Melis' – MAY 20, 2015 comments on “Lees Ferry Recreational Trout Fishery Management Recommendations: The Voice of Lees Ferry Anglers, Guides, and Businesses”

I defer to my fisheries colleagues on most of the content of the draft plan that is beyond my expertise, but offer the following comments/observations in response to several sections of the plan that I have had experiences with.

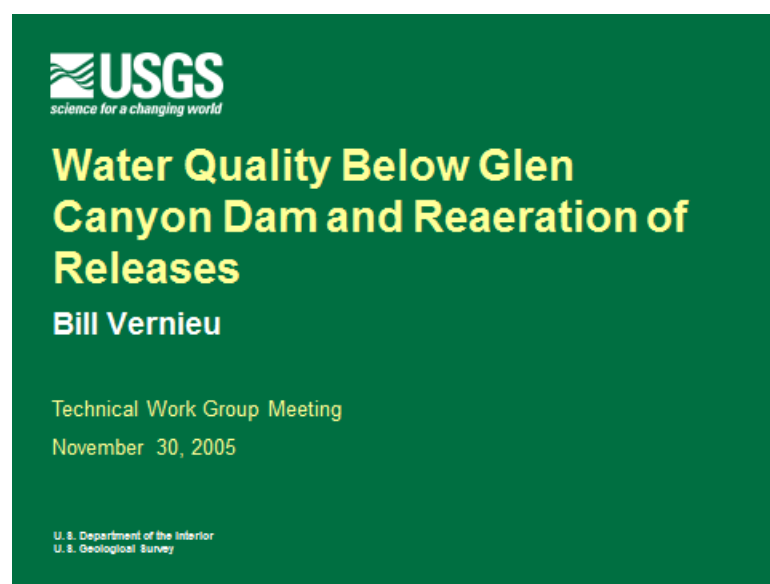
The plot on the right-above, clearly shows from data collected at Lees Ferry in late OCT 2014, that the lowest daily levels of DO in the tailwater fishery occurred at the lowest dam releases – flows that ranged down to about 7,000 cfs. So, perhaps from these data one would conclude that lower flows will always equate to lower DO, but that was the focus of the “low-turbine release” experiments conducted jointly by GCMRC and BuRec in fall 2005 (plot on left-above, and slides to follow).

By operating some of the turbines at release levels lower than would normally be scheduled, DO levels were actually observed to increase during the 2005 experiments, and this was only done at night when power plant operations were “off-peak”. Also, recall that dam releases in 2005 were the warmest between 2003 and present, so trying to repeat these “experimental” releases in future periods of combined conditions of warm water and low DO releases seems like something that the group may want to actually propose for continued testing, rather than oppose?

I don’t know for sure how the individual turbines were operated at night during fall 2014, but I must assume that they were not being operated in a way similar to tests conducted in fall 2005 (engineers did not want to do it, but did for the sake of science I guess).

So, I think that we need to be clear that there are different ways of releasing “low flows” from GCD and some of them might result in elevated DO levels (fall 2005), while others will result in the lowest DO conditions of a given day (fall 2014).
